ENGINEERING CHANGE NOTICE NO.

04559

DWG NO. 646.9700

DWG TITLE: CUTTER SUB ASSY

SHEET 2, ZONE D7 IS:

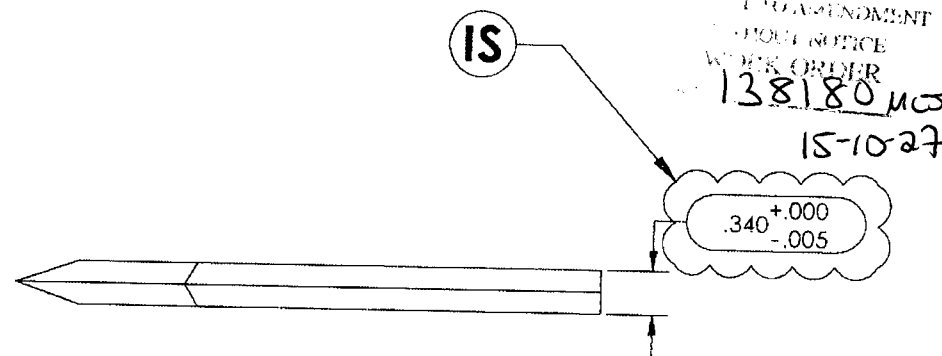
REASON: ADDED DIMENSION AND TOLERANCE

SHEET 5, ZONE B5 IS:
